PCN Date: 12/7/2012		Effective Date: 3/12/2013
Title: Adding test and shipping site, with different tape & reel material (lokreel, cover tape and carrier tape) for EM357		
Originator: KF Lee	Phone: 65 6511 6428	Dept: SM/QA
Customer Contact: Kathy Haggar	Phone: 1-512-532-5261	Dept: Sales
PCN Type: <input checked="" type="checkbox"/> Datasheet <input type="checkbox"/> Foundry <input checked="" type="checkbox"/> Packing <input type="checkbox"/> Product Revision <input type="checkbox"/> Assembly <input type="checkbox"/> Labeling <input type="checkbox"/> Discontinuance <input checked="" type="checkbox"/> Test <input type="checkbox"/> Other		
Last Order Date: Not Applicable		
PCN Details		
Description of Change: Silicon Labs is adding ASE Chung Li, Taiwan (ASECL) as a test and shipping site for EM357 in addition to the current site; STATS Chippac Malaysia (SCM). As a result, Silicon Labs is required to use different packing materials (lokreel, cover tape & carrier tape) for EM357 as per the description below;

APPENDIX A (carrier tape comparison for 48QFN 7X7)

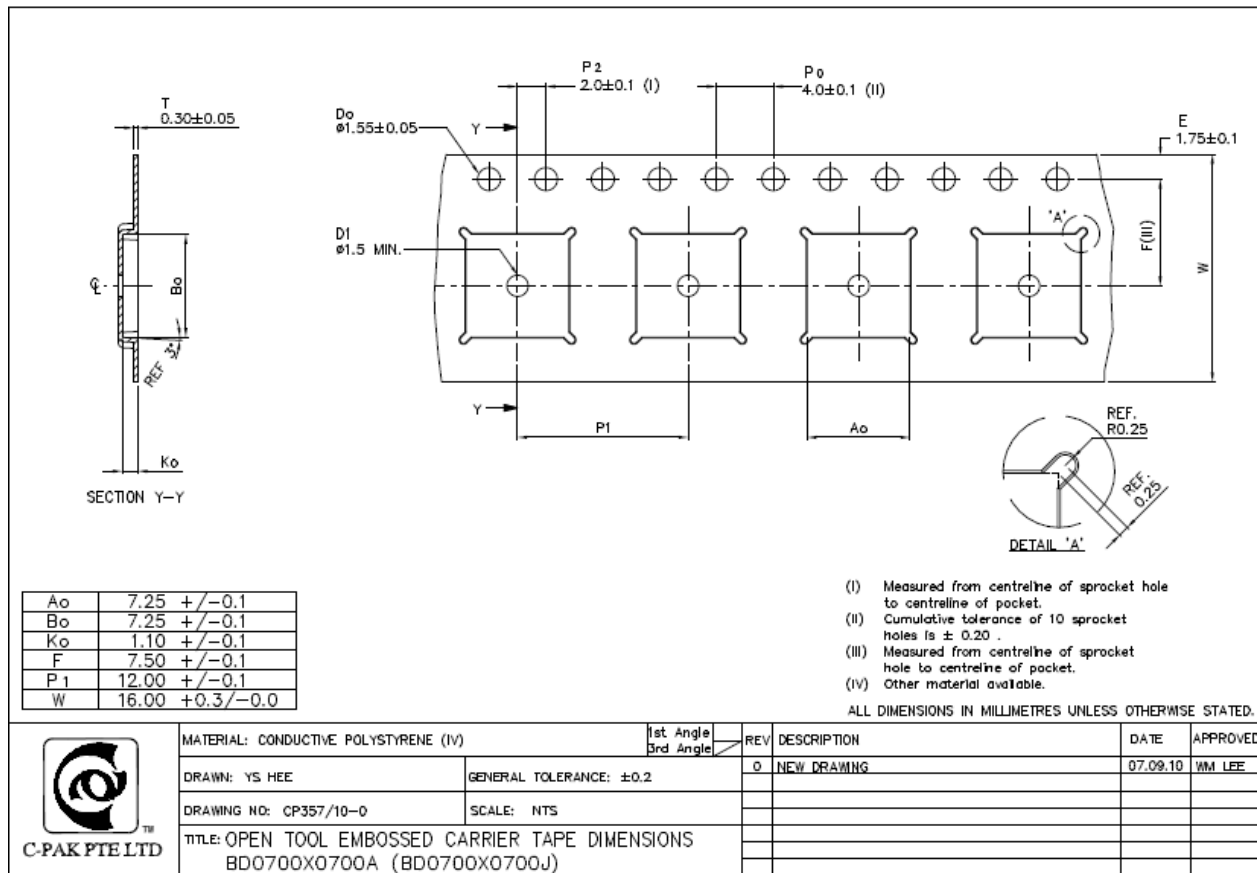
Critical dimension/package type	SCM	ASECL	Comparison Remarks
Material	Carrier Tape	Carrier Tape	
Vendor	Cpak	Cpak	
Part #	R021-0700X	BD0700X0700J	
Measurement Unit	MM	MM	MM
Carrier tape width	15.7 - 16.3	16.0 - 16.3	OK
Pocket pitch	11.9 - 12.1	11.9 - 12.1	OK
Rail hole pitch	3.9 - 4.1	3.9 - 4.1	OK
Pocket position to sprocket hole	7.4 - 7.6	7.4 - 7.6	OK
Sprocket hole diameter	1.5 - 1.6	1.5 - 1.6	OK
Ao	7.15 - 7.35	7.15 - 7.35	OK
Bo	7.15 - 7.35	7.15 - 7.35	OK
Ko	1.0 - 1.2	1.0 - 1.2	OK

APPENDIX B (cover tape comparison on 48QFN 7X7)

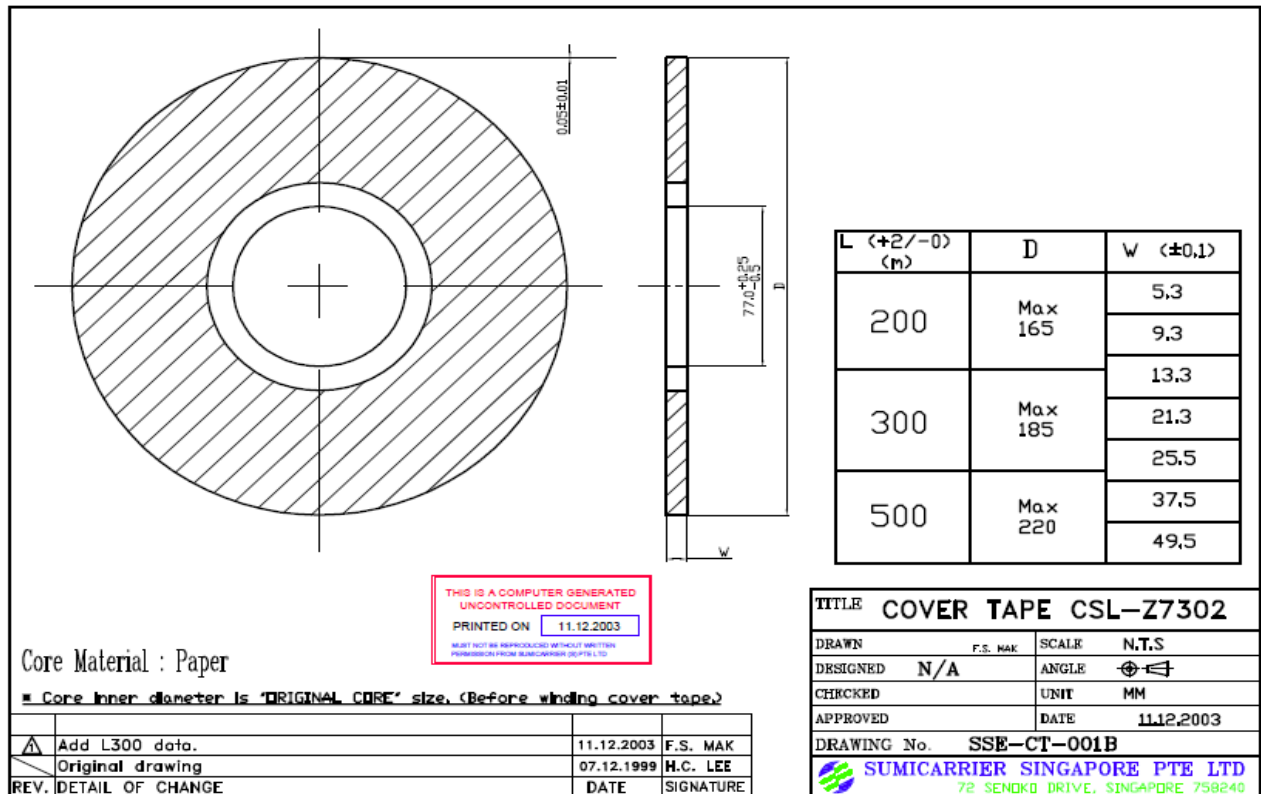
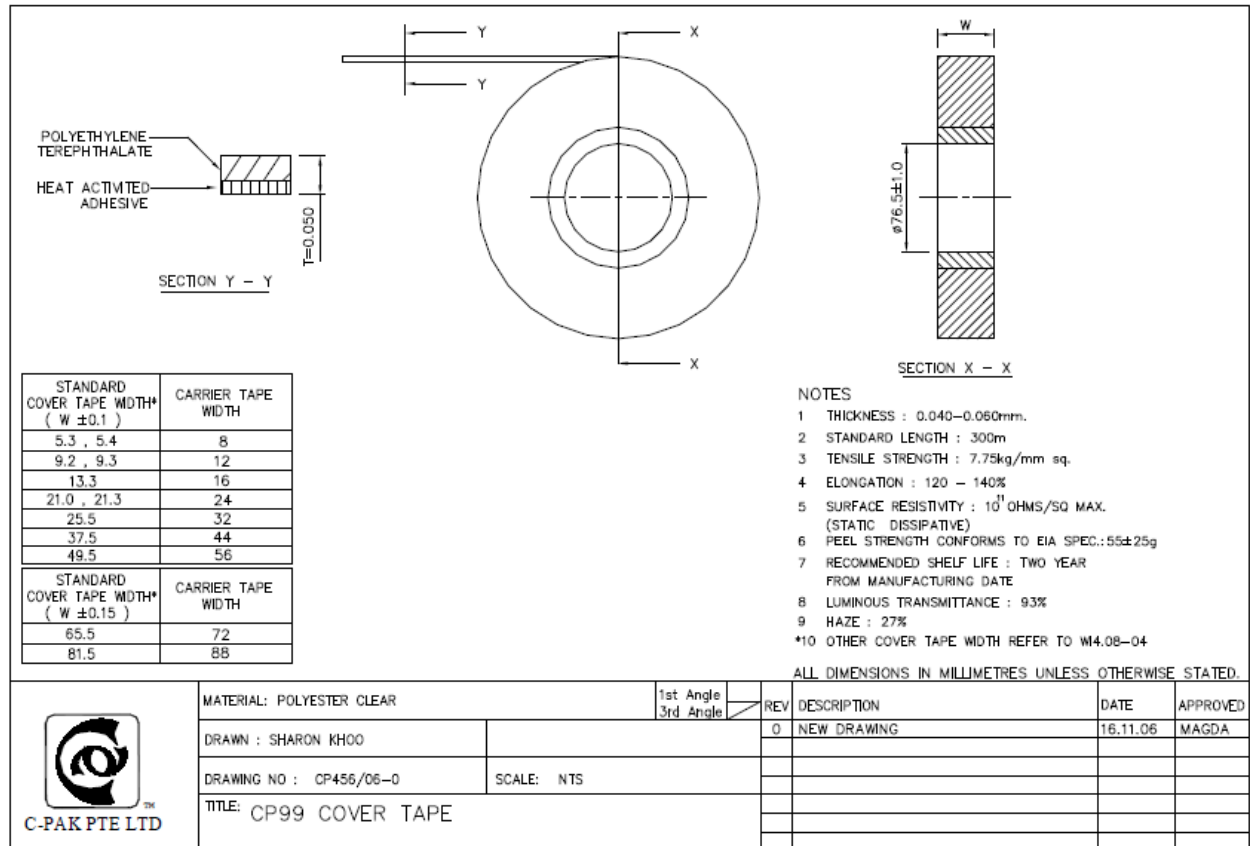
Critical dimension/package type	SCM	ASECL	Comparison Remarks
Material	Cover Tape	Cover Tape	
Vendor	Sumi Carrier	Cpak	
Part #	R021-0114B	CP99-133A	
Measurement Unit	MM	MM	MM
Width	13.2 - 13.4	13.2 - 13.4	OK
Length	302 Meter	300 Meter	OK
ESD Properties			
Surface Resistivity (Ohms / SQ)	10^{11}	10^{11}	OK

APPENDIX C (lokreel comparison on 48QFN 7X7)

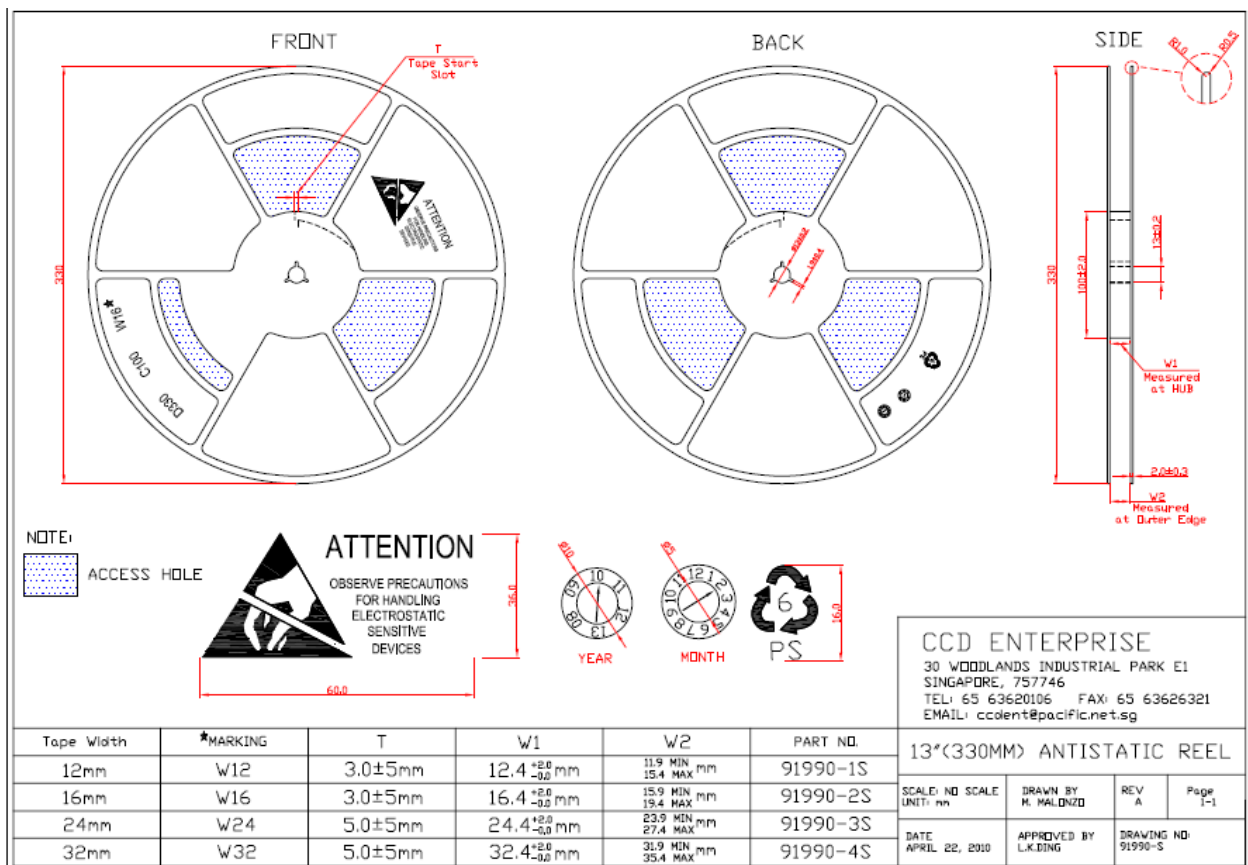
Critical dimension/package type	SCM	ASECL	Comparison Remarks
Material	Lock Reel	Lock Reel	
Vendor	CCD Enterprise	Cpak	
Part No	R021-1462X	43000051P1	
Measurement Unit	MM	MM	MM
Reel Hub Width (W1)	16.4 - 16.6	16.4 - 16.6	OK
Reel Outer Width (W2)	15.9 - 19.4	16 - 22.4	Difference 0.1 - 3 (meeting EIA 481 spec.)
ESD Properties			
Surface Resistivity (Ohms / SQ)	$10^6 - 10^{11}$	$10^6 - 10^{12}$	OK
